ORIGINATION FORM

Proposed Revisions to a Standard Plans Index
(Please provide all information — Incomplete forms will be returned)

Index Number: 521-660

Index Title: Light Pole Pedestal - Bridge

SHEET
4 of 4

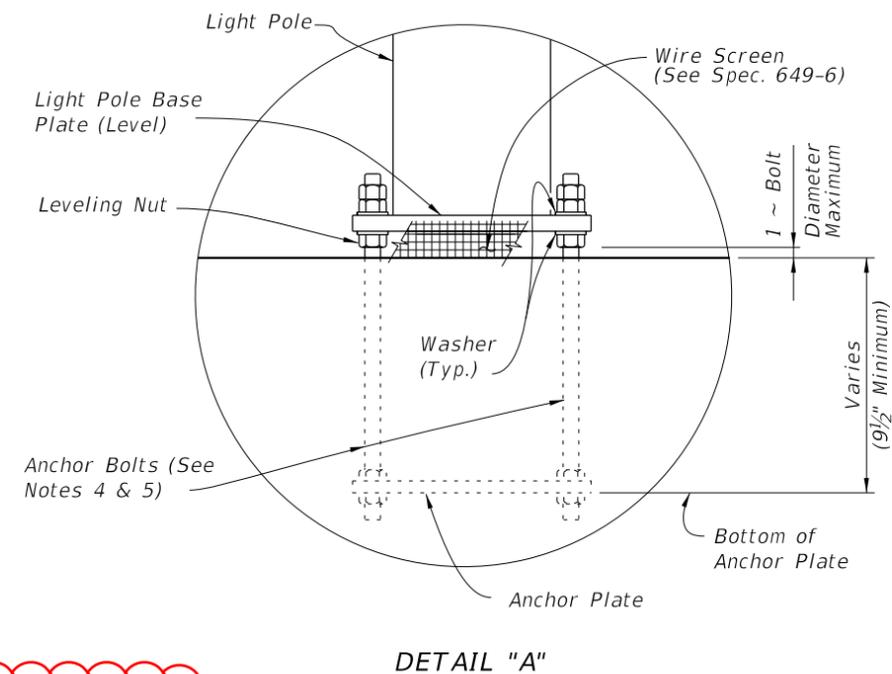
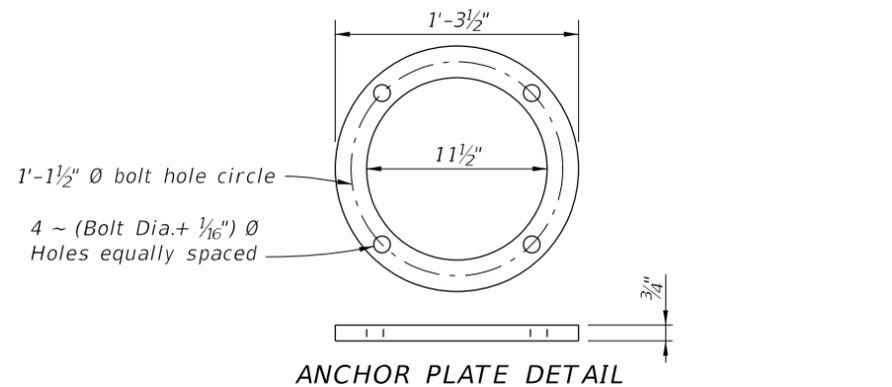
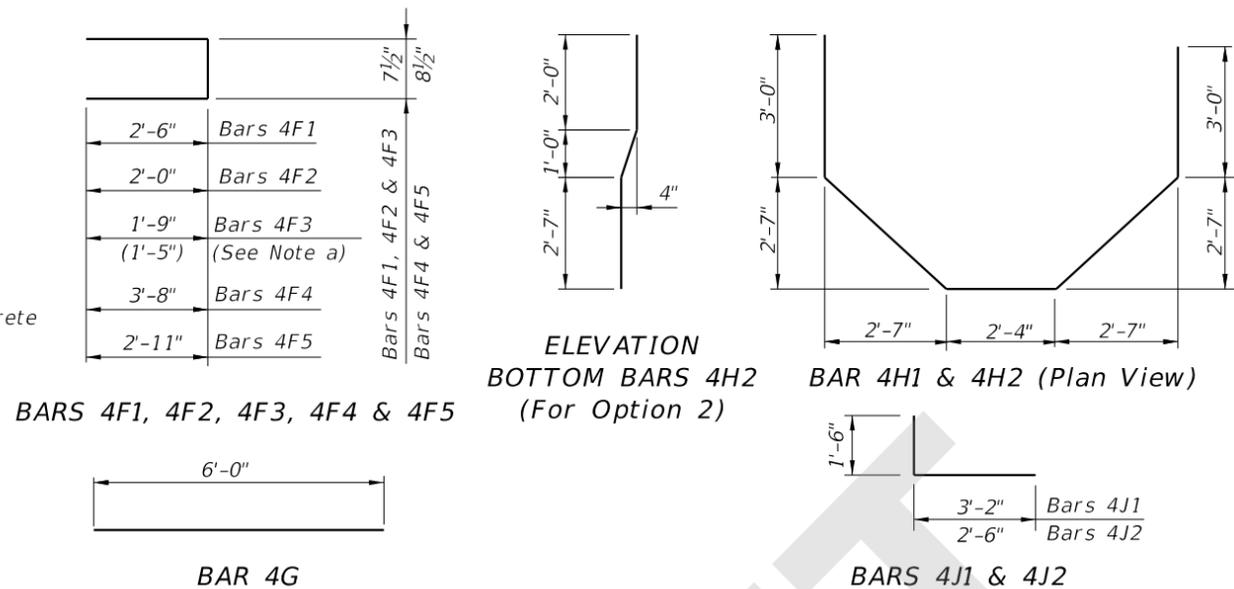
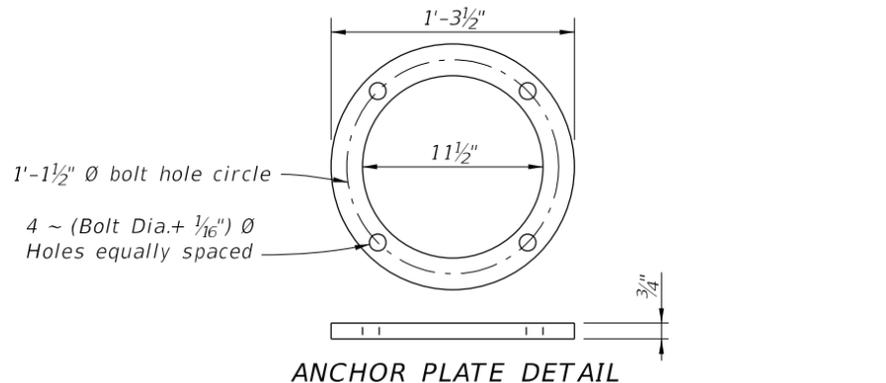
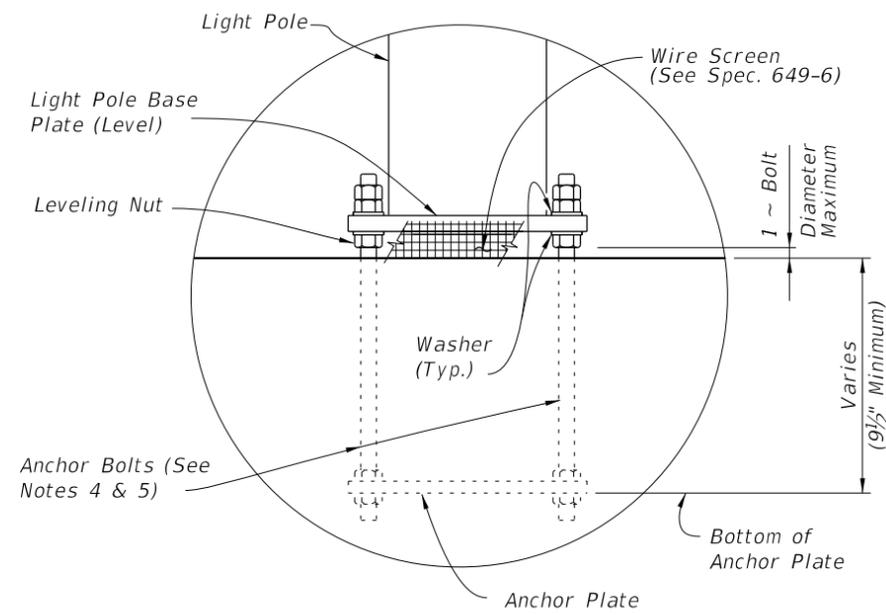
Sheet 4: Changed wind speeds in Table 1

Update to match current criteria

WIND SPEED (MPH)	ARM LENGTH (Ft.)	BRIDGE DECK HEIGHT (Ft.)*		
		DESIGN MOUNTING HEIGHT 40 Ft.	45 Ft.	50 Ft.
130	≤ 15	75	75	75
150	≤ 15	75	75	75
170	8 & 10	75	75	45**
170	12 & 15	75	75	25**
